Final Comprehensive Field Reconnaissance Report

Demicks Lake Pipeline Right-of-Way
McKenzie County, North Dakota

Project B1904193 (Activity 1.5)

Re: Comprehensive Field Reconnaissance Report
Demicks Lake Pipeline Right-of-Way
McKenzie County, North Dakota

20" DEMICKS LAKE PIPELINE			
NATURAL GROUND PROFILE CROSSING ROUTE @ MILE POST 62.33 MCKENZIE COUNTY, NORTH DAKOTA			
SCALE 1"=60'	PROJECT NO. OPL-008	DRAWING NUMBER OPL008JTAM-MP-88-023	REV. 0

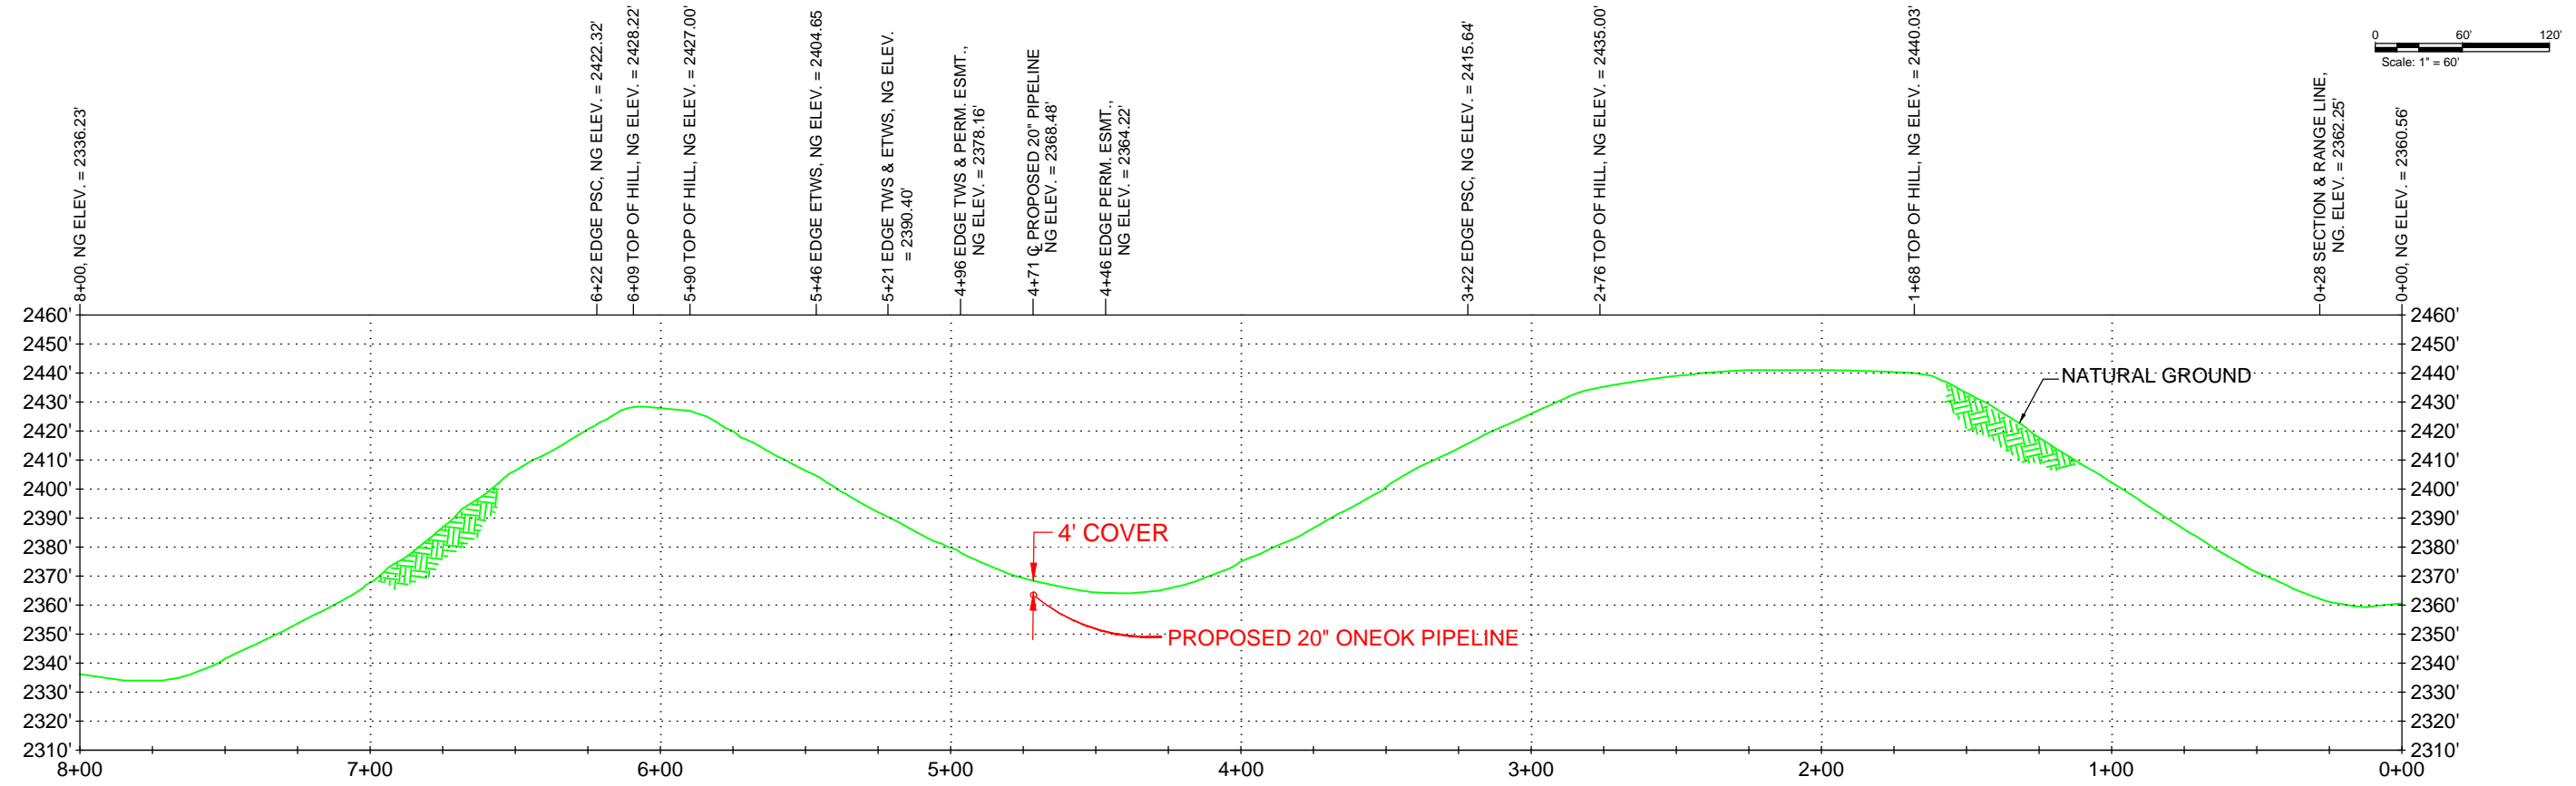
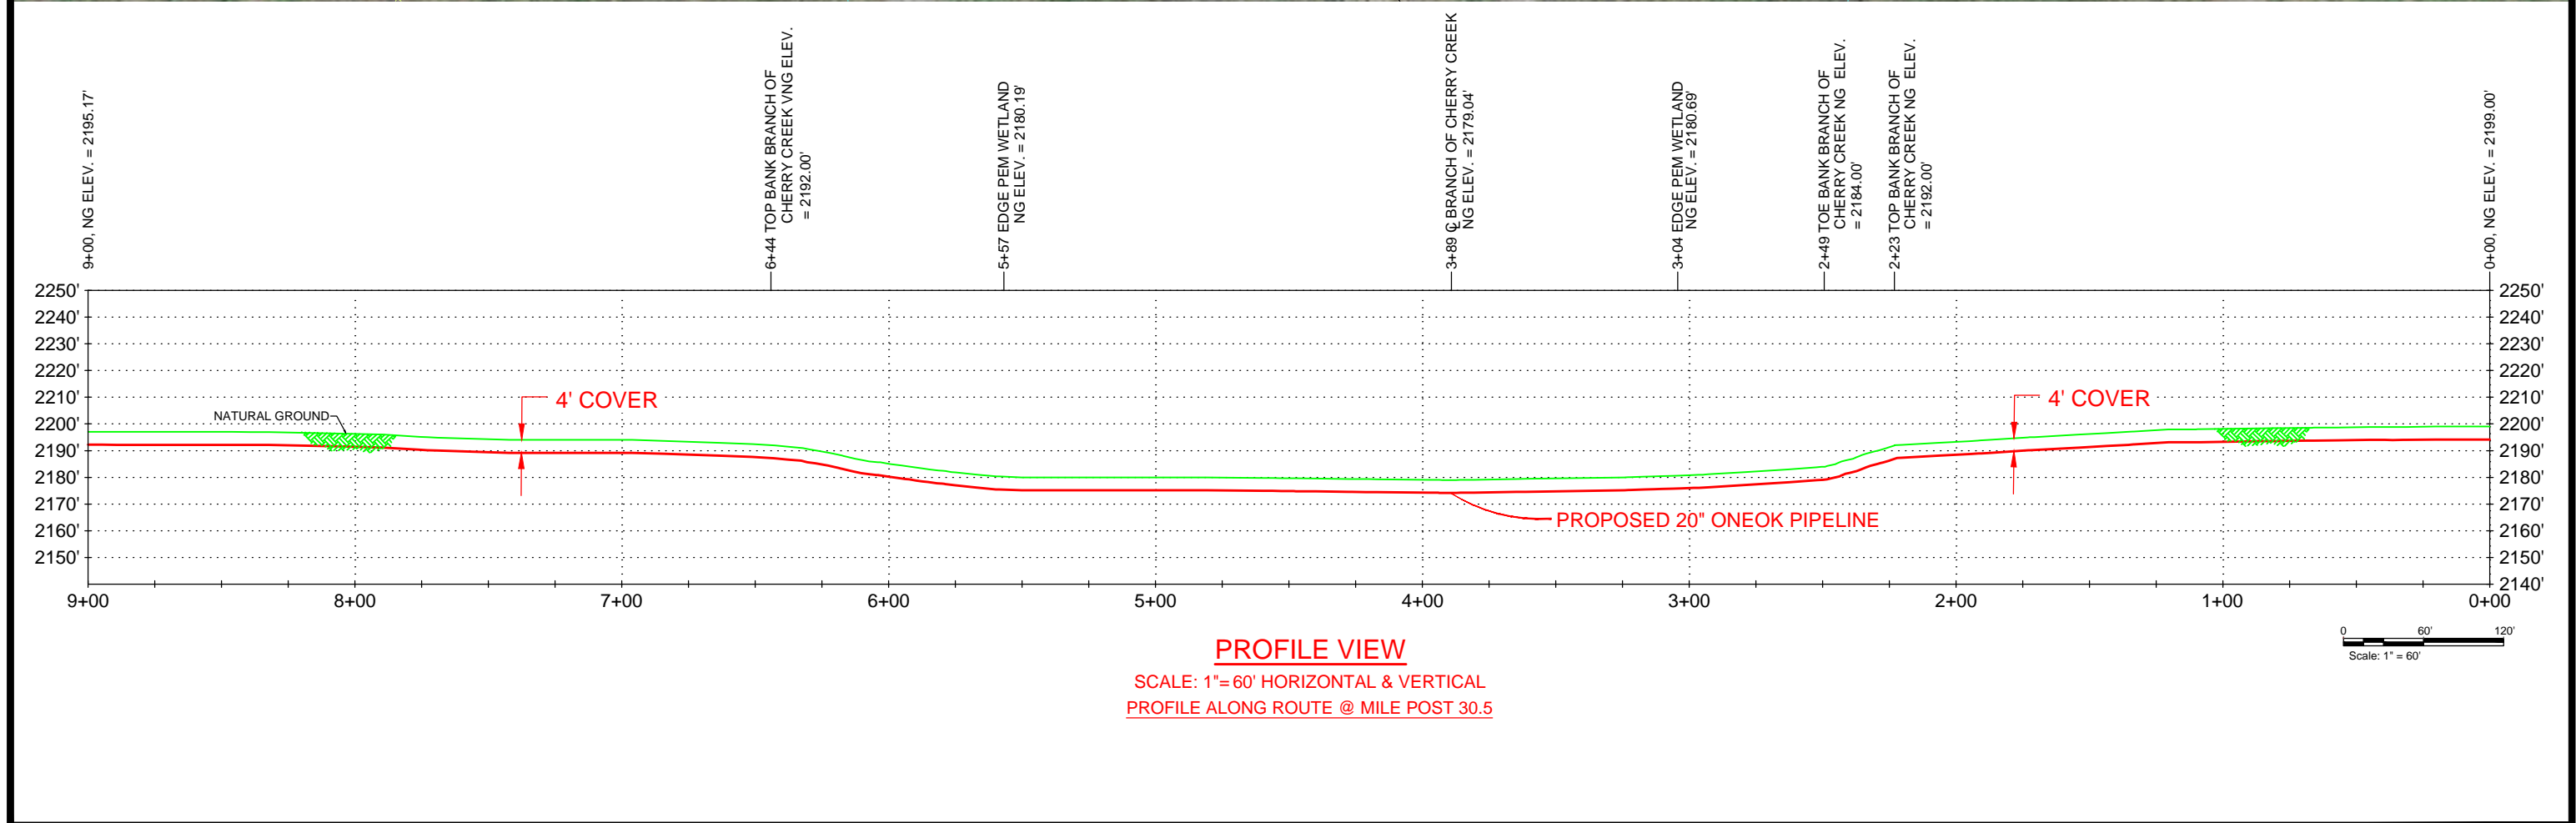
During our field reconnaissance, no signs of slope instability were observed along either slope of the valley. The existing west slope is approximately 2:1 (H:V) and spans from elevations 2,364 to 2,428, so benching or sloping would be needed during construction to minimize the risk of creating slope instability. As similar to MP61.1, benches should be no more than 4 feet in height and extend adequately into the slope as needed for construction of the pipeline. Finished slopes at this site should remain at 3:1 (H:V) or flatter.

We understand the alternative would be to shift the alignment east up to 50 feet to the flatter area at the bottom of the valley. Based the existing topography, it may be more suitable to move the pipeline east approximately 30 feet, near Station 4+46, to take advantage of the flatter terrain so benching/sloping would not be required, saving on construction effort and/or costs.

HORIZONTAL DIRECTIONAL DRILL CHERRY CREEK, TWO PEM WETLANDS & EPHEMERAL STREAM M.P. 37.88 DEMICKS LAKE PIPELINE INDEX #10597			
DES.: EP	AFE#:	DATE: 04/19/19	
DR.: EP		DWG. NO.:	
CH.: CR	SCALE: NOTED		
AP.: CR	CAD#:	OPL008JTAM-MP-20-006	REV. 1

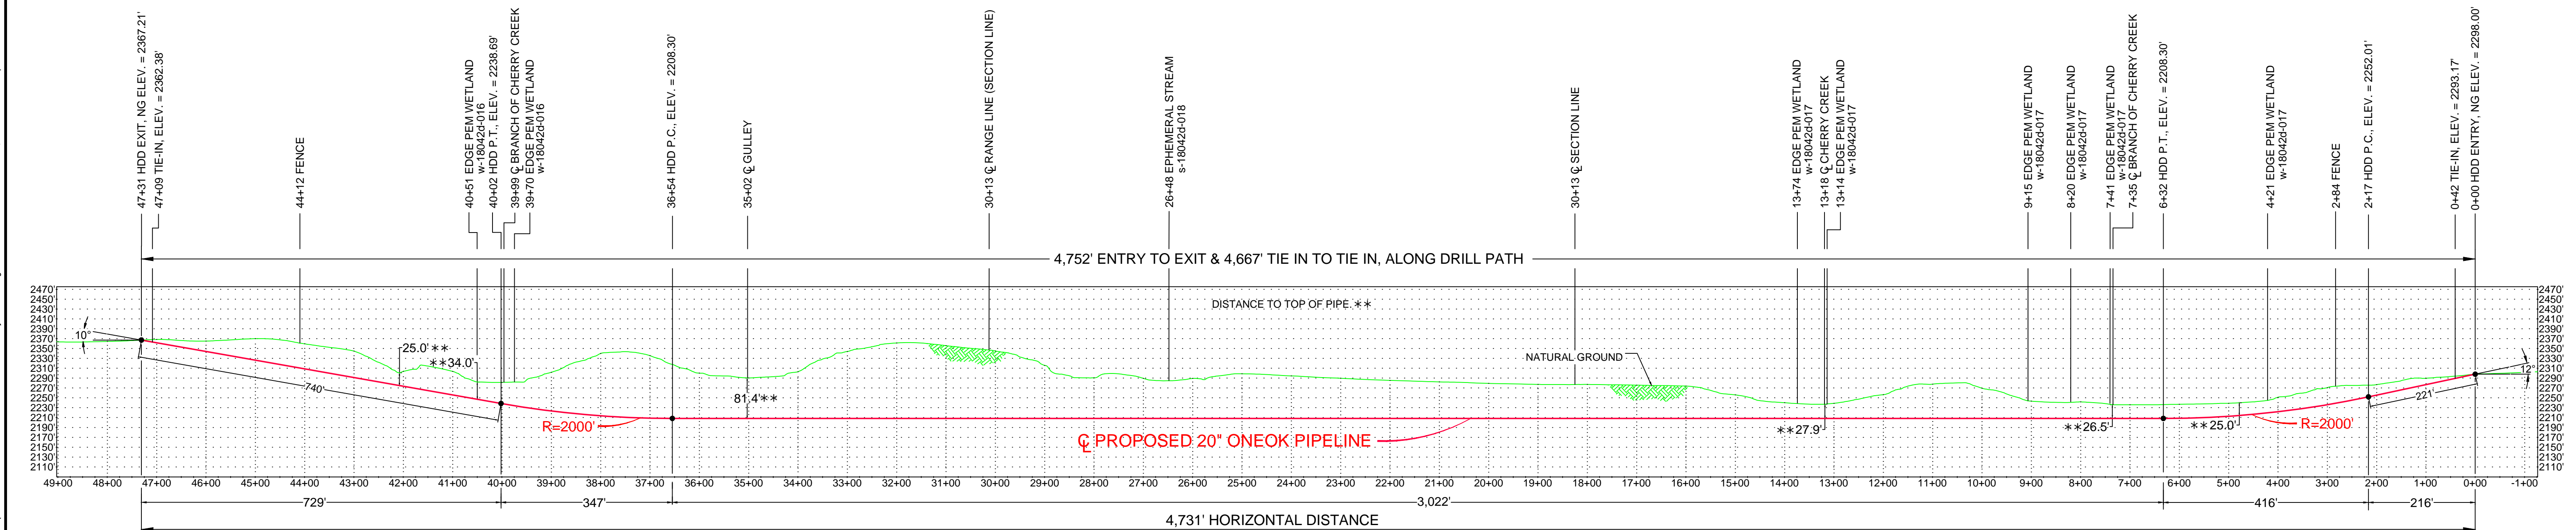
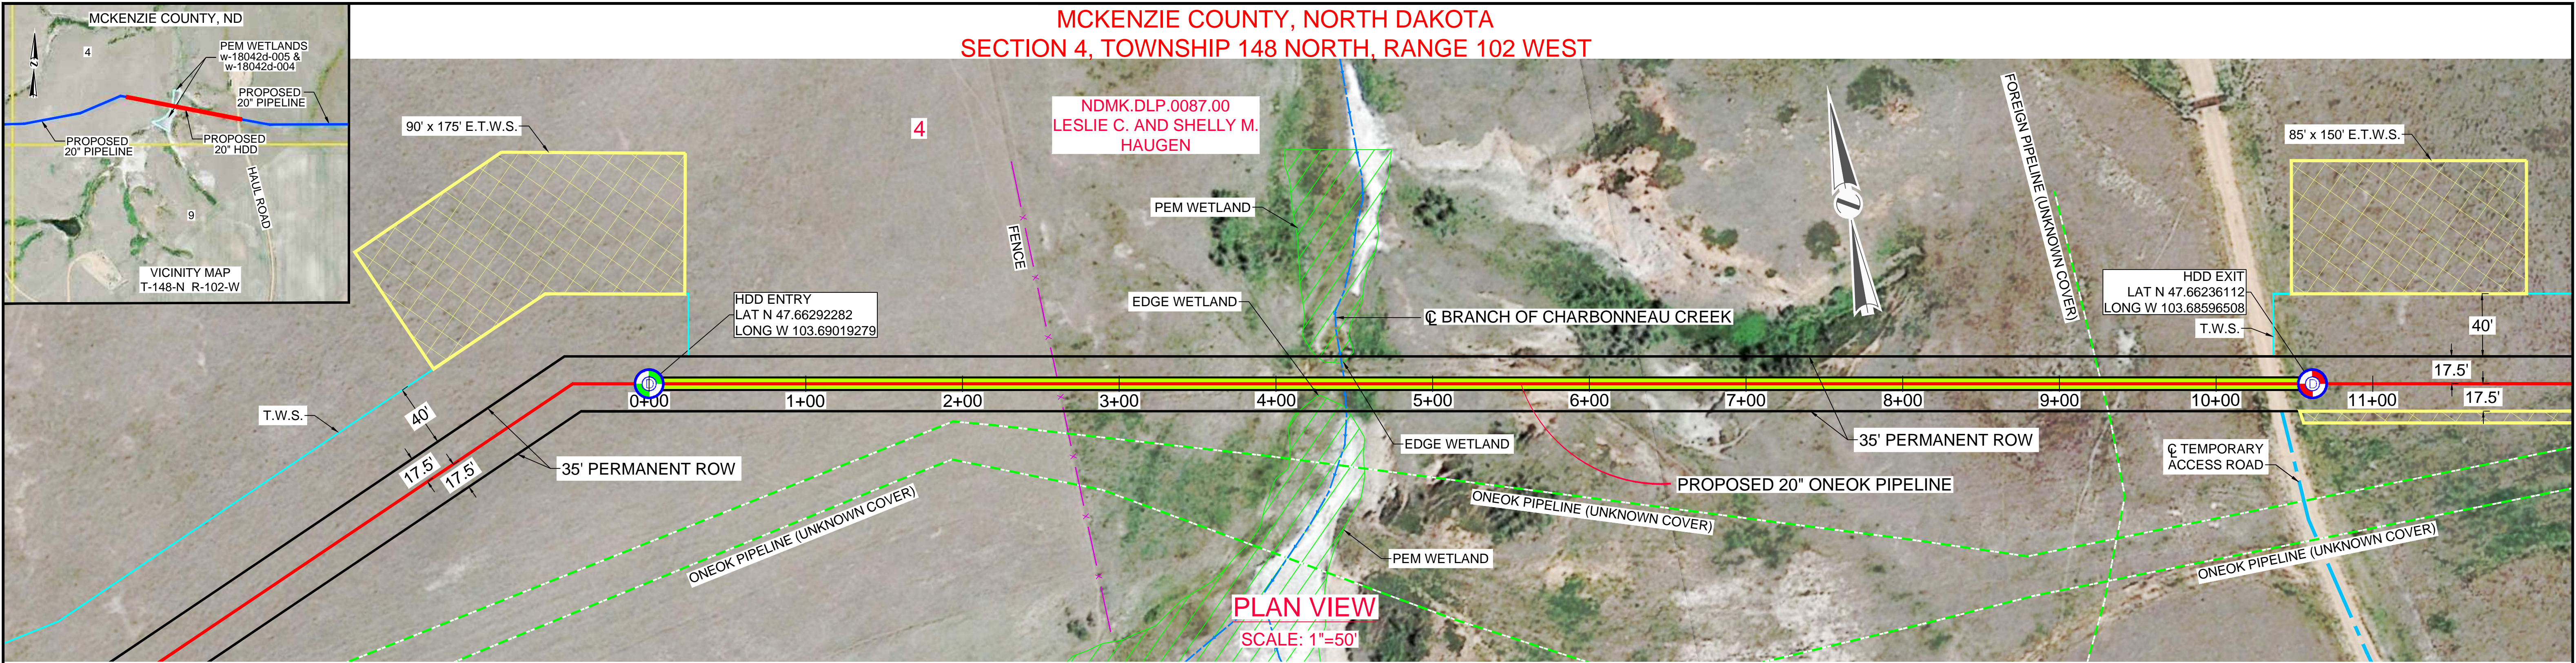
This section of pipeline near MP38.1 extends horizontally from east to west for approximately 4,731 feet. Based on the construction plans, the minimum depth below low points (wetlands, valleys, etc.) is 25 feet. The pipeline in this area crosses two wetlands, Cherry Creek, and several eroded valleys. The geologically unstable area was identified between Stations 33+00 and 38+00. Based on our site reconnaissance in this area, there were several north/northeast facing slopes, particularly near Stations 16+00 (directly west of Cherry Creek) and 36+00 (within the 'unstable' area), which indicated slope instabilities. However, the slopes containing dense tree cover and indicate slump failures appeared to be shallow in nature and likely caused by historic erosion at the toe.

The planned depths below these areas' low points are about 28 feet (Station 16+00) and 81 feet (Station 36+00) below the existing ground surface. Based on the geologic conditions of these areas and the planned HDD depths, construction may proceed as planned. Geotechnically, the planned depth below wetland areas is sufficient.

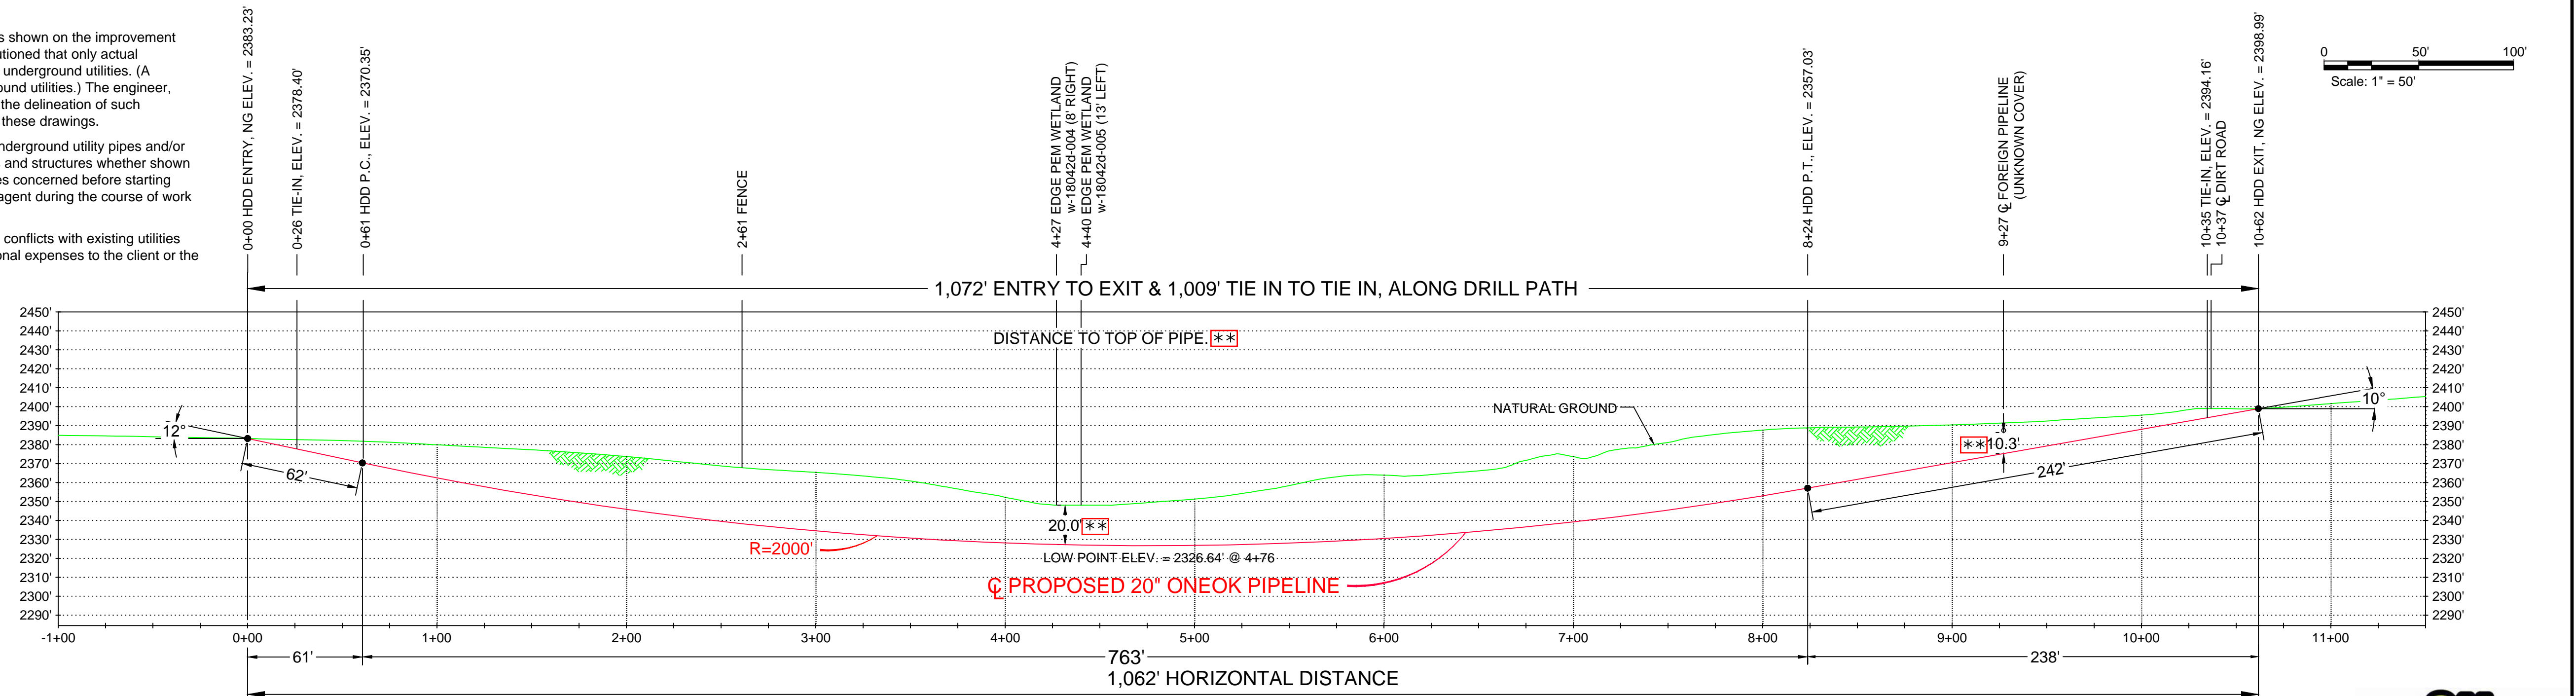
The pipeline near MP47.2 is planned to extend horizontally from east to west for approximately 1,062 feet. Based on the provided plans, the minimum depth below the wetland and potentially geologically unstable area (lowest point) is approximately 20 feet. The area of concern was identified between Stations 4+00 and 5+00. Based on our site reconnaissance in this area, there were no signs of slope instability or distress other than varying degrees of erosion/degradation within the surface scoria stratum.

The planned depth below the lowest point in this area is about 20 feet (Station 4+78) below the existing ground surface. Since there were no signs of slope instabilities and the HDD depth is sufficient, construction may proceed as planned.
